**SOLICITATION AMENDMENT  
MODIFICATION DE L'INVITATION**

<b>Title - Sujet</b> Bowden Roof Upgrade	
<b>Solicitation No. - N° de l'invitation</b> EP922-183351/A	<b>Amendment No. - N° modif.</b> 002
<b>Client Reference No. - N° de référence du client</b> CSC	<b>Date</b> 2018-05-07
<b>GETS Reference No. - N° de référence de SEAG</b> PW-\$PWU-183-11355	
<b>File No. - N° de dossier</b> PWU-7-40267 (183)	<b>CCC No./N° CCC - FMS No./N° VME</b>
<b>Solicitation Closes - L'invitation prend fin</b> <b>at - à 02:00 PM</b> <b>on - le 2018-05-14</b>	<b>Time Zone</b> <b>Fuseau horaire</b> Mountain Daylight Saving Time MDT
<b>F.O.B. - F.A.B.</b> <b>Plant-Usine:</b> <input type="checkbox"/> <b>Destination:</b> <input type="checkbox"/> <b>Other-Autre:</b> <input type="checkbox"/>	
<b>Address Enquiries to: - Adresser toutes questions à:</b> Tikhonovitch (RPC), Alex	<b>Buyer Id - Id de l'acheteur</b> pwu183
<b>Telephone No. - N° de téléphone</b> (780) 901-7940 ( )	<b>FAX No. - N° de FAX</b> (780) 497-3510

## Addendum No. 1

**Project #:** R.083696.001  
**Project Name:** BOWDEN INSTITUTION, A18  
REPAIR AND B21 ROOF REPLACEMENT

ASK. # 1

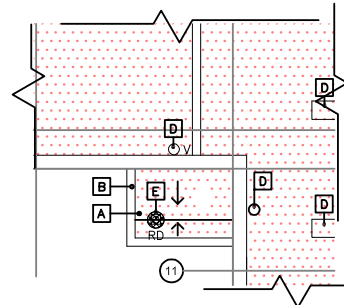
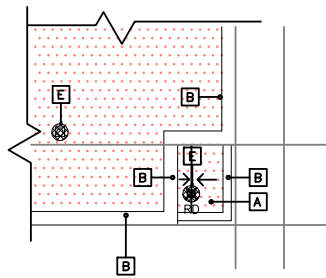
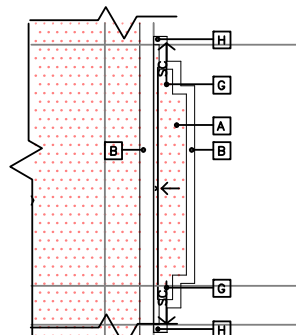
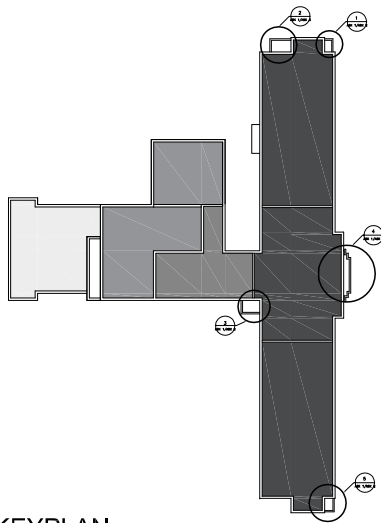
- Item 5.** Clarification: small roof areas to be included on the scope of work, refer to attached ASK #1&2 for locations.

- [A] REMOVE EXISTING ROOF SYSTEM DOWN TO EXISTING ROOF DECK TYPICAL.
- [B] REMOVE EXISTING CAP FLASHING ON PARAPETS.
- [D] REMOVE EXISTING FLASHING.
- [E] REMOVE EXISTING ROOF DRAINS TO BE REPLACED.
- [G] EXISTING SCUPPER TO BE REPLACED.
- [H] EXISTING DOWNSPOUT TO BE REPLACED.

**ASK. # 2**

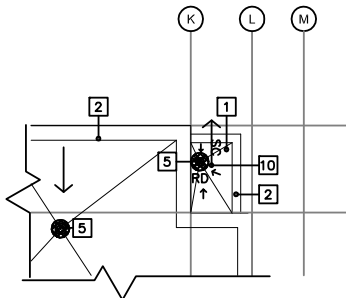
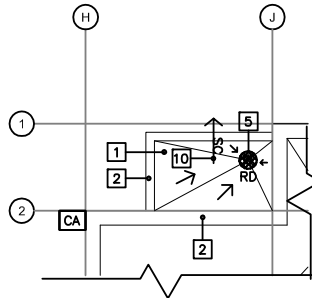
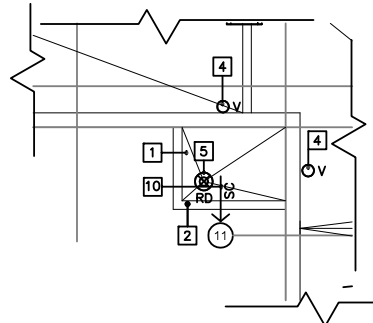
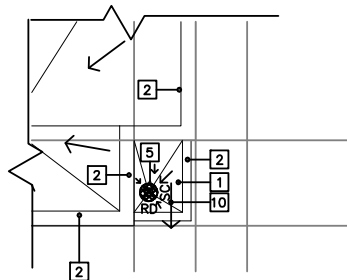
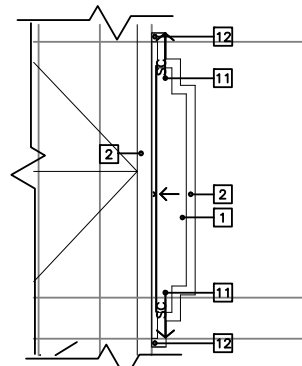
- 1 RE-ROOF WITH NEW ROOF ASSEMBLY; REFER TO ROOF ASSEMBLIES.
- 2 INSTALL NEW CAP FLASHING ON PARAPETS TO MATCH EXISTING.
- 4 INSTALL NEW FLASHING; REFER TO SPECS.
- 5 INSTALL NEW ROOF DRAIN.
- 10 INSTALL OVERFLOW SCUPPER.
- 11 NEW SCUPPER TO BE INSTALLED.
- 12 NEW DOWNSPOUT TO BE INSTALLED C/W CONCRETE SPLASH PADS.
